LAKE HAVASU CITY, ARIZONA  
ADMINISTRATIVE SERVICES DEPARTMENT  
♦ PROCUREMENT ♦

**INVITATION TO BID**  
**PORT DRIVE AND QUEEN'S BAY LIFT STATION UPGRADES**  
**PROJECT NO. B25-PW-107027-028-500661**  
**ADDENDUM NO. 3**  
**MAY 23, 2025**

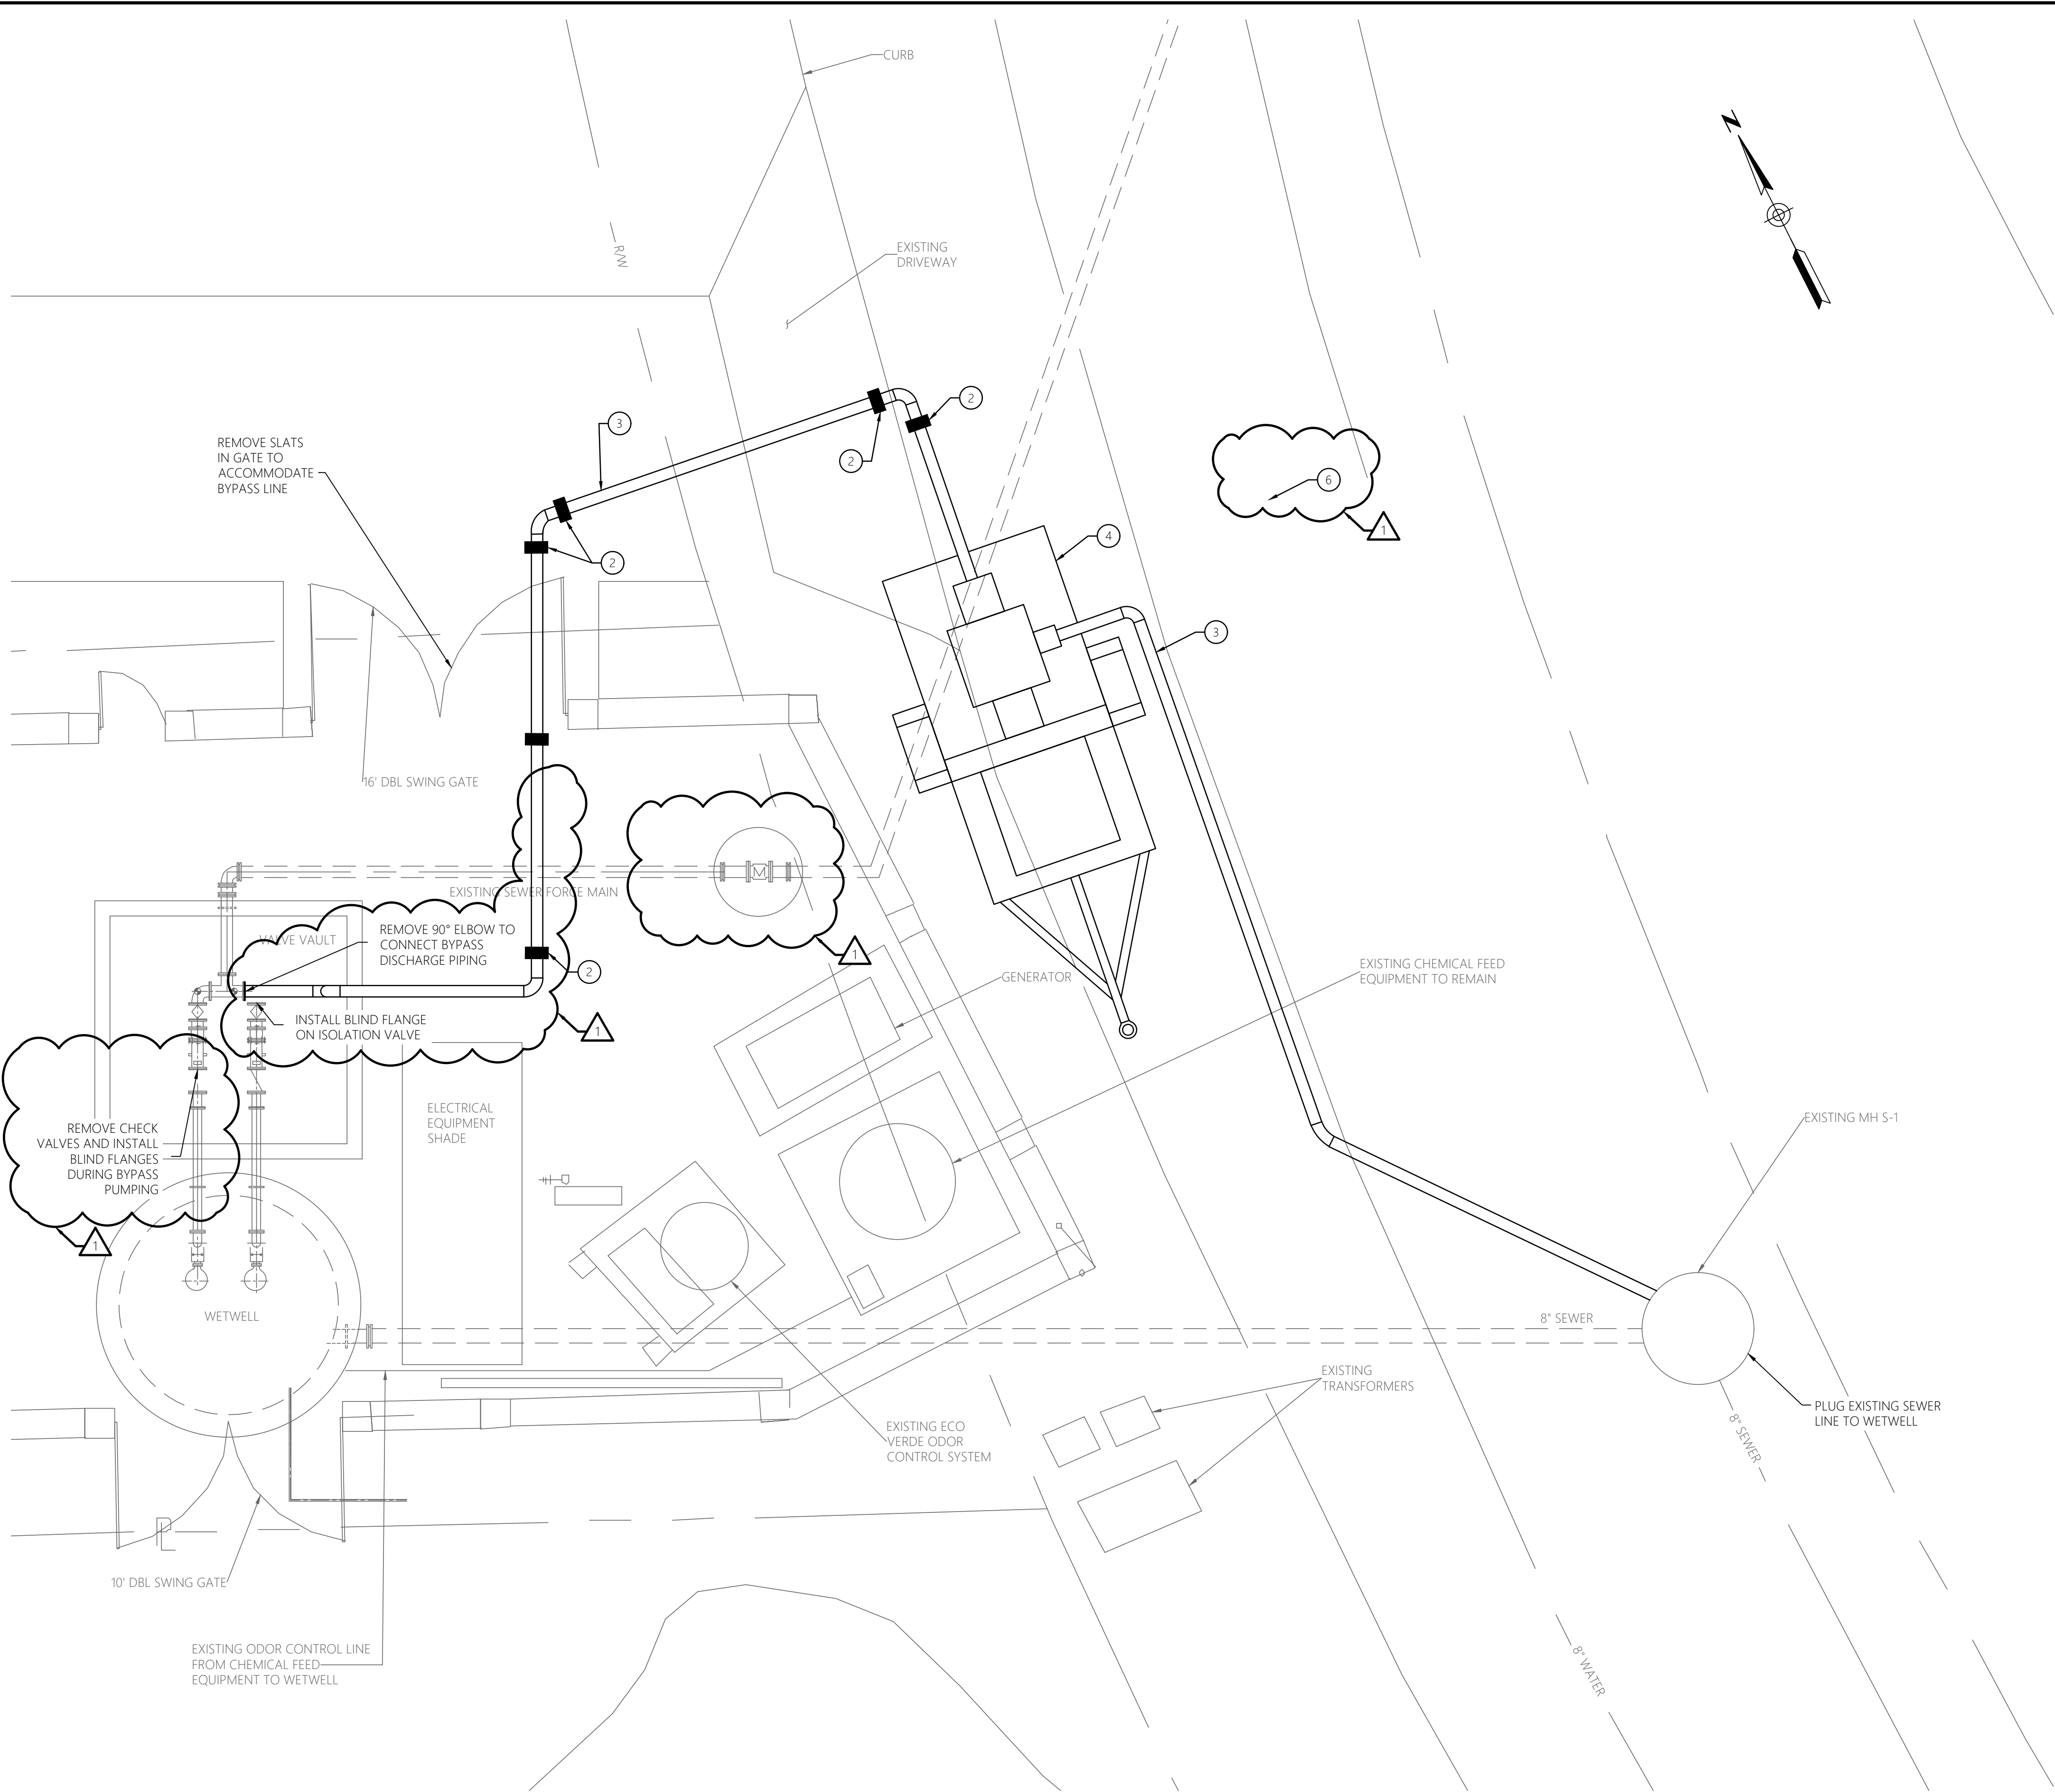
**Question 16:** At Queen's Bay, is it okay to tie in the discharge bypass at the valve vault instead of the flowmeter manhole?

COPYRIGHT © 2025	
Checked	BH
Drawn	JL
Design	VS
Date	5/16/2025
Revision Note	ADDENDUM 3 - TWO ELECTRIC PUMPS TO BE PROVIDED PER BYPASS SYSTEM.
Rev No	1
BYPASS CONNECTION TIE-IN REVISED AS SHOWN

**Answer 16:** The City is not changing any piping or valves in the valve vault and is fine with tie in there. Updated drawings for Queen's Bay to reflect this request have been provided (see updated M-01-Q in the attachment).

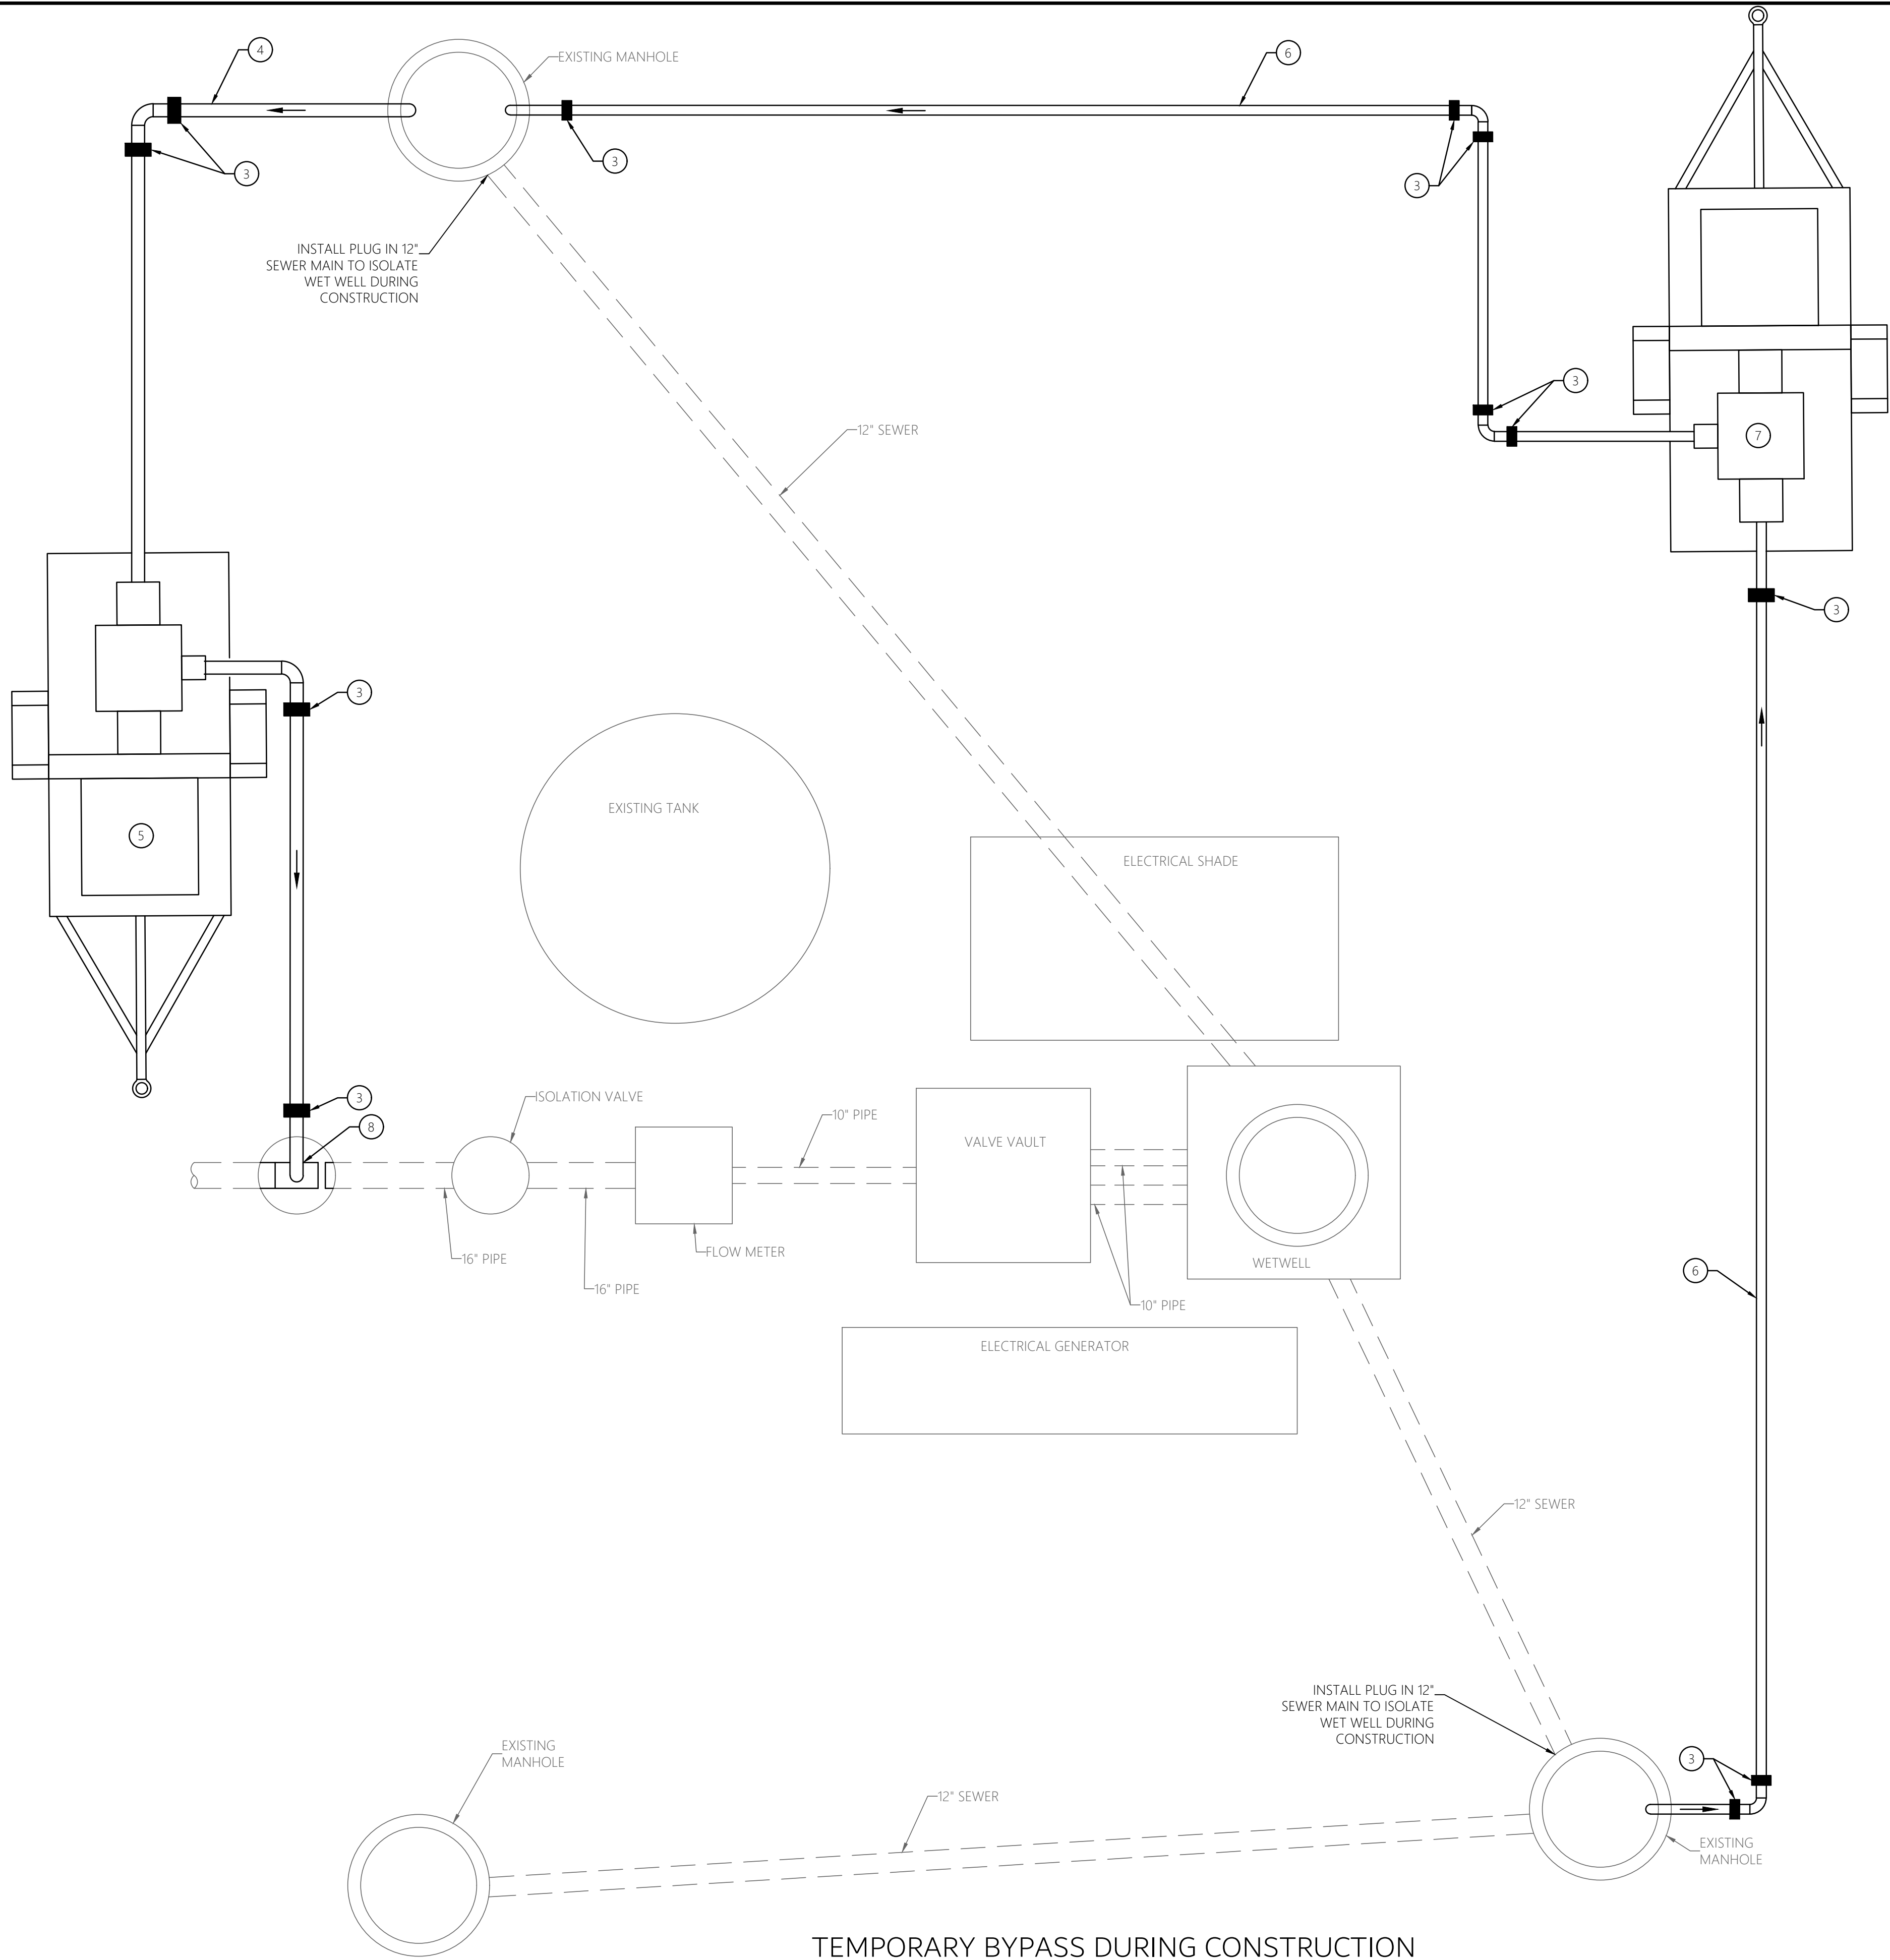
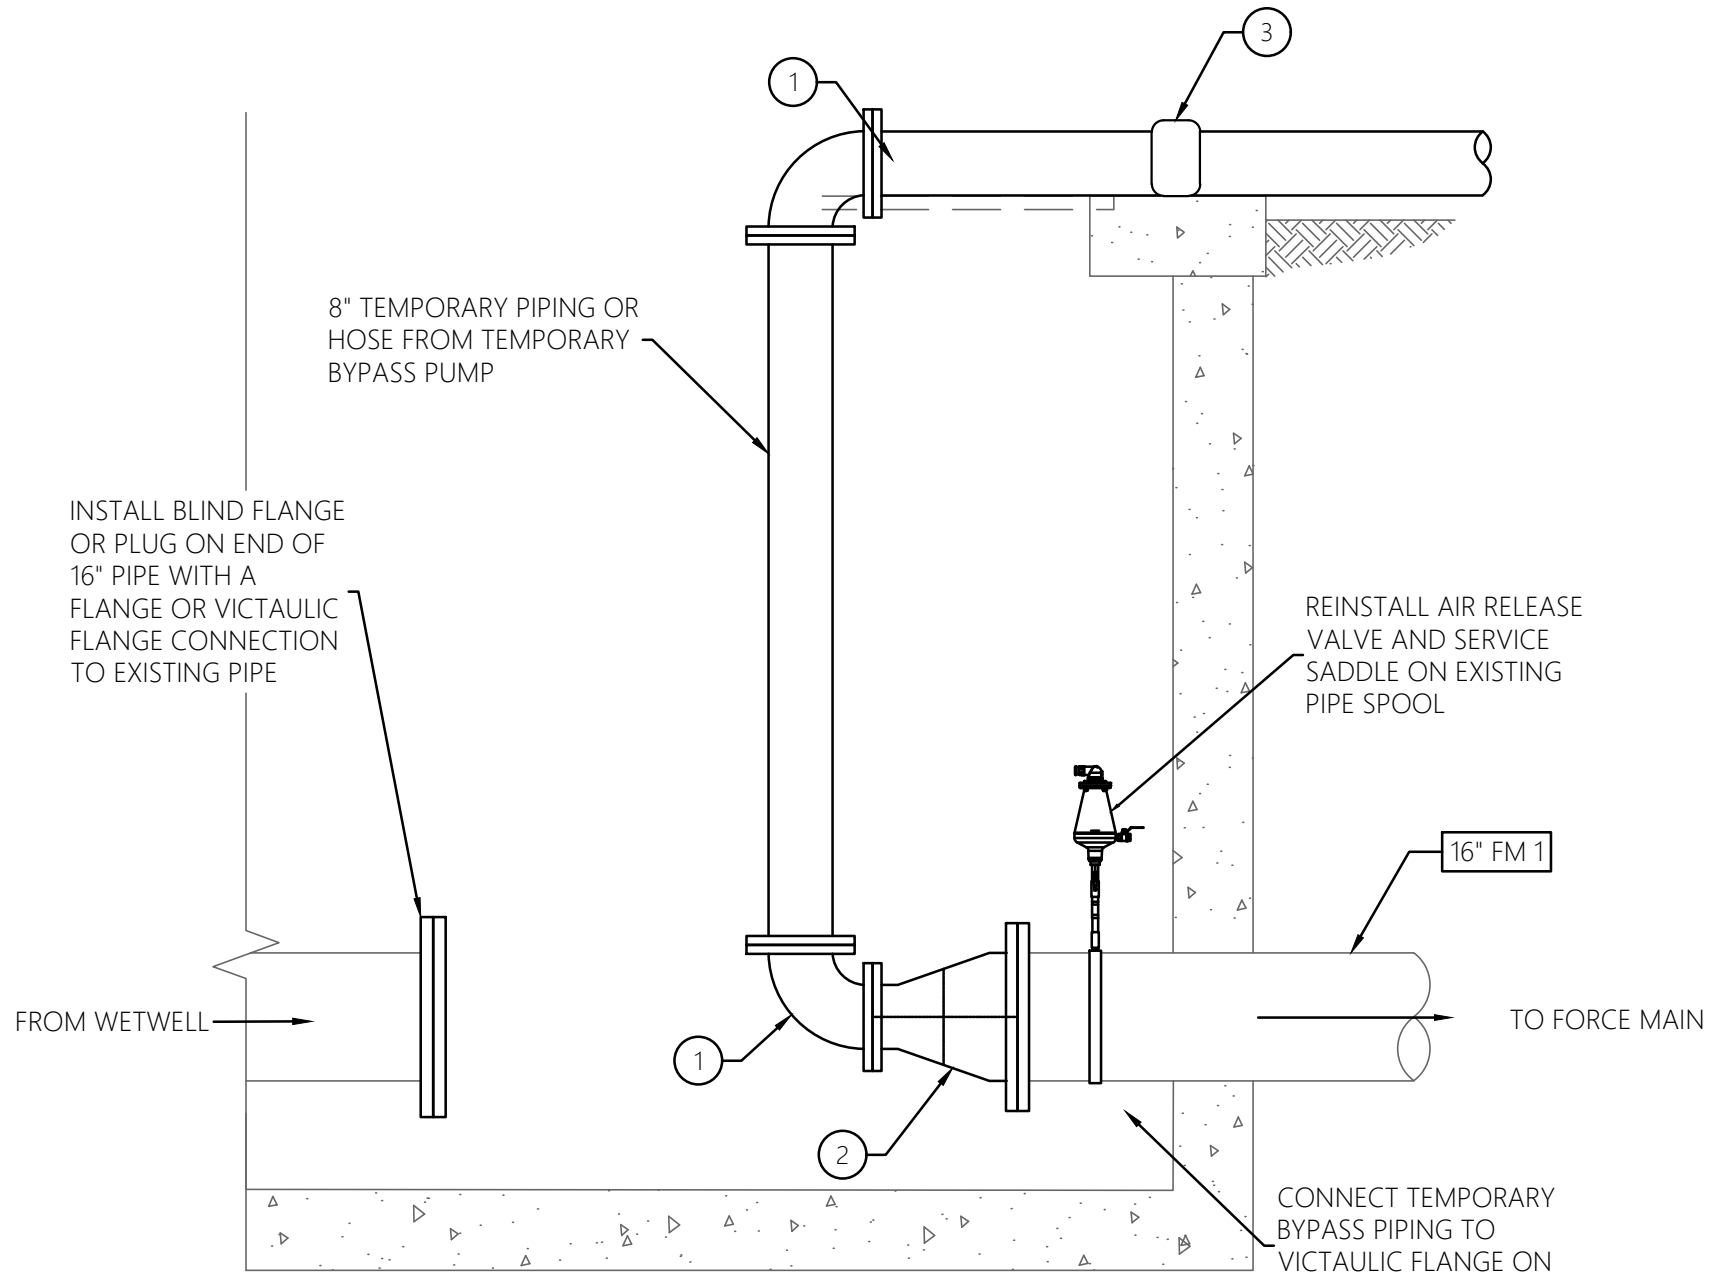
⑧	BYPASS CONNECTION SHOWN AS PER DETAIL IN SHEET M-01

COPYRIGHT © 2025	
Checked	BH
Drawn	JL
Design	VS
Date	5/16/2025
Revision Note	ADDENDUM 3 - TWO ELECTRIC PUMPS TO BE PROVIDED PER BYPASS SYSTEM.
Rev No	1

**Answer 7:** The following is to be provided for the electric bypass pumping systems, which are the primary bypass pumps to be used while the wet well is out of service:

1. Dual electric pump skids per the revised construction drawings (see Attachment A)
2. Contractor to provide "Smart Cover monitoring" at each manhole that the bypass pumps are pumping out of. The smart cover will detect levels in the manhole and send High Level alarms and monitoring by email and text to the Contractor and City.
